Service Bulletin

Reinforcement Plate Installation on aircraft SB-ASTM-CTLS-14

Installation of Reinforcement Plate in upper attachment points of 4-point Harnesses.

Fig. 3-3-2-1.

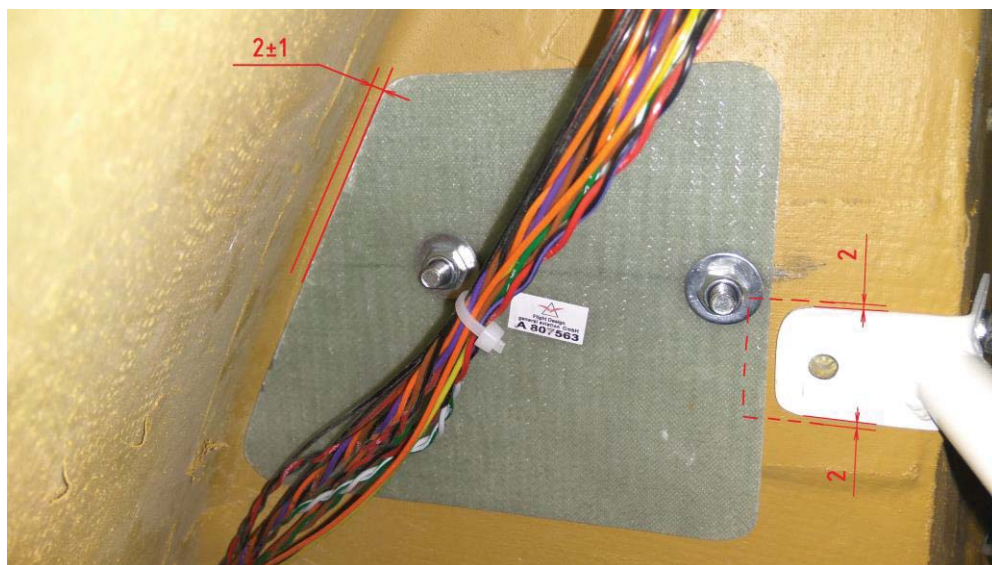
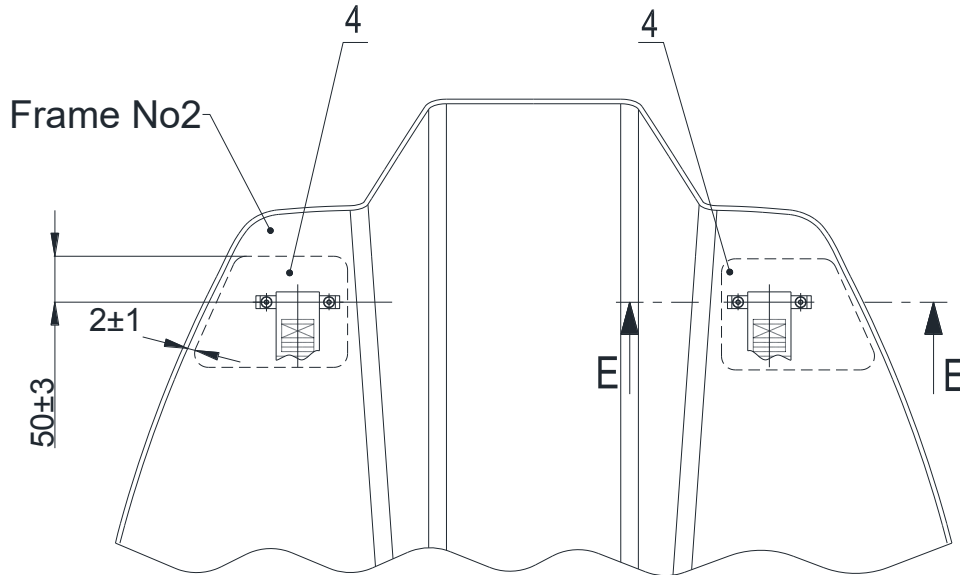
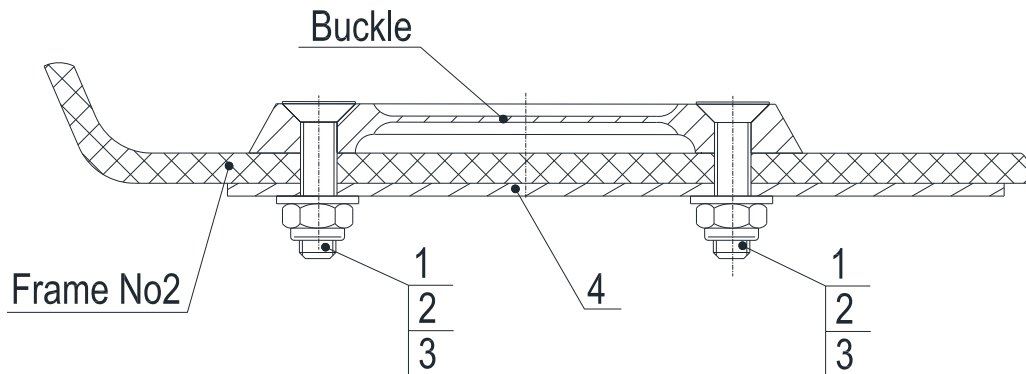
1. Position the plates according to the sketch on the frame. Mark the hole position. In case the plate overlaps with the parachute rescue system bracket attachment, mark and cut out a notch or trim the plate to give the correct placement. See Fig. 3-3-2-1.
2. Drill the 6 mm holes according to the markings.
3. Make a test installation and verify that the plate has correct position and a minimized gap to the frame.
4. Make final installation according to the Sketch 1.

Fig. 3-3-3

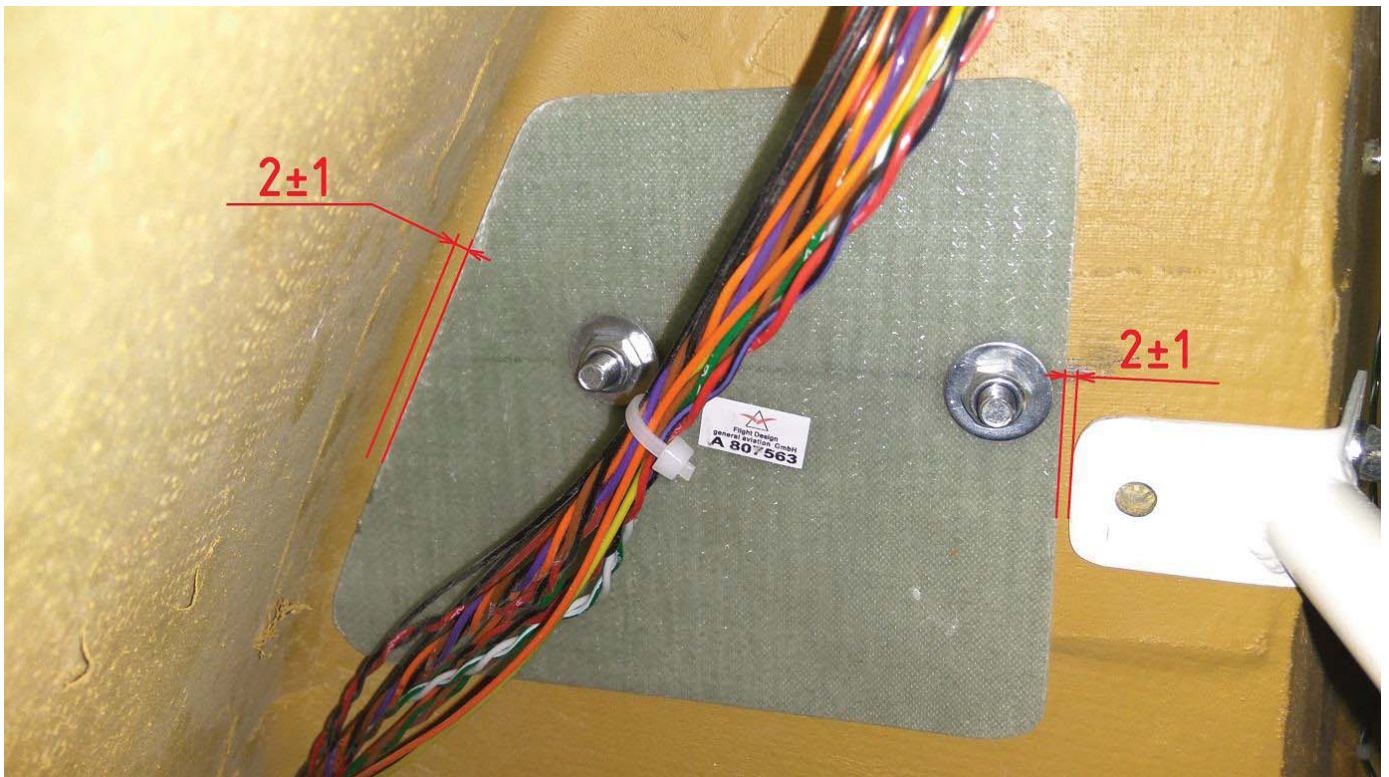
Sketch 1

Mark all bolt-nut connections with "Paint Maraflor TK 36 red" or equivalent torque stripe.

Tightening torque nuts: 9Nm.
